MCPB  
Item # 12A and B  
3-05-09

**SUBJECT:** Staff Recommendations for Planning Board approvals of:  
A. **Special Protection Area (SPA) Preliminary/Final Water Quality Plan, and**  
B. **Preliminary Forest Conservation Plan associated with Mandatory Referral No. 07606-MCPS-1, Paint Branch High School**

**SUBJECT:** Mandatory Referral No. 07606-MCPS-1: Paint Branch High School Modernization, -  
14121 Old Columbia Pike, R-200 Zone and the Environmental Overlay Zone for the  
Upper Paint Branch Special Protection Area, 1997 Approved and Adopted Fairland  
Master Plan

ATTACHMENT 2:  
EXISTING SITE PLAN  
PROPOSED SITE PLAN

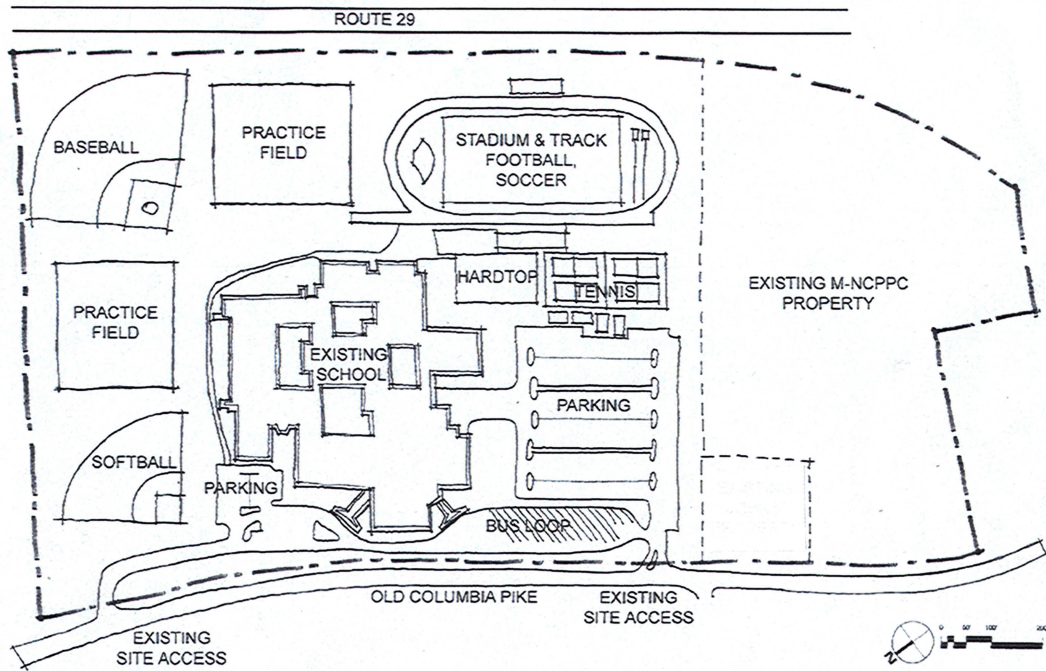
Vehicular circulation includes four points of entry. One entrance services the faculty/staff parking lot, bus loop and small parking facility. The three other points of entry provide a loop system that accesses the main parking lot and the smaller parking lot dedicated to community use during all hours.
